ADDENDUM NO. 03

PROJECT: Suffern Central School District
RP Connor Heating System Conversion

CPL PROJECT NO. 12396.23

DATE: 7/13/2023

1 FIRST FLOOR PLAN - AREA A
H201A SCALE: 1/8" = 1'-0"

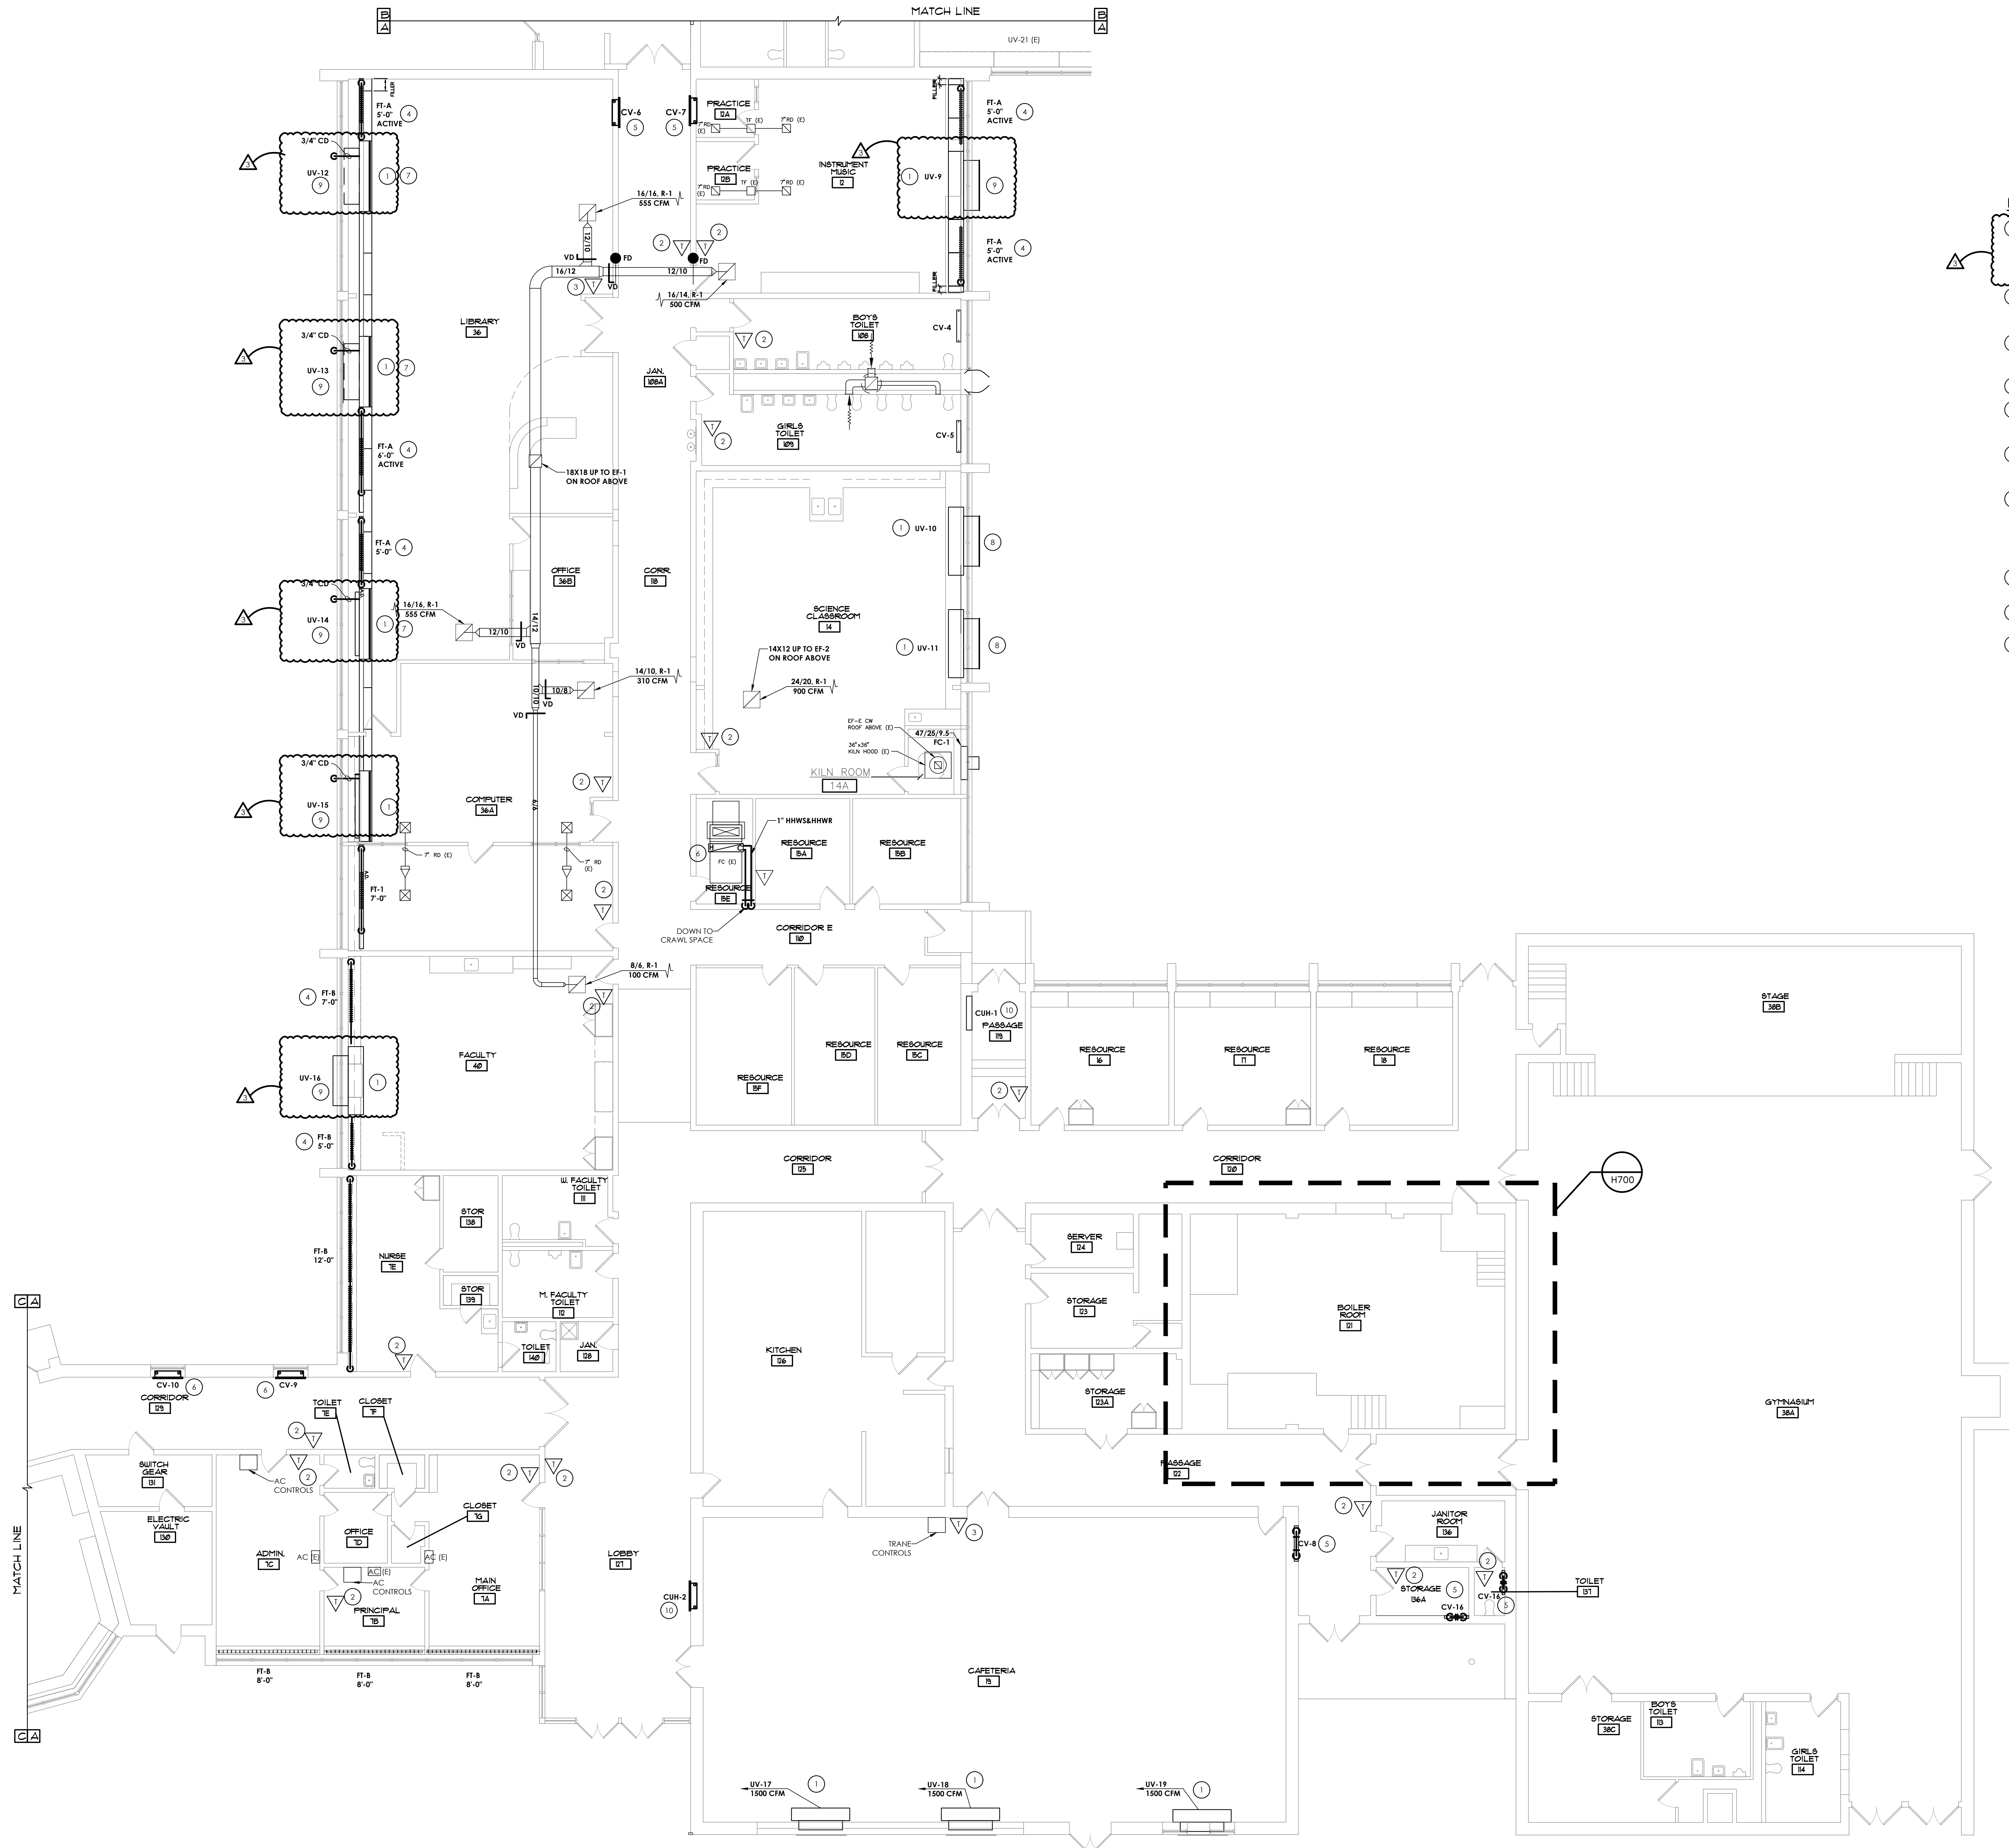
- 1.1 The intention is to have the UV's be provided with DX coils with the intention of future condenser connection. Addendum 1 is to add the 8 condensers as a bid alternate, but the DX coils are base bid.
- 1.2 There is no glycol in this system.
- 1.3 The only new work on drawing H201B is the hot water piping connecting to the existing loop pumps for that area. Everything else is existing to remain.
- 1.4 Existing UV louvers are to remain and be reused as part of the base bid. The louvers are to be replaced as part of alternate MC-01. The only exceptions are UV-10, UV-11, as those are in new locations so will need new louvers as base bid, UV-17-19 louvers to remain regardless.

- 2.1 Replace drawing H201A with revised H201A drawing attached.
- 2.2 Replace drawing H201C with revised H201C drawing attached.
- 2.3 Replace drawing H700 with revised H700 drawing attached.
- 2.4 Replace drawing H701 with revised H701 drawing attached.
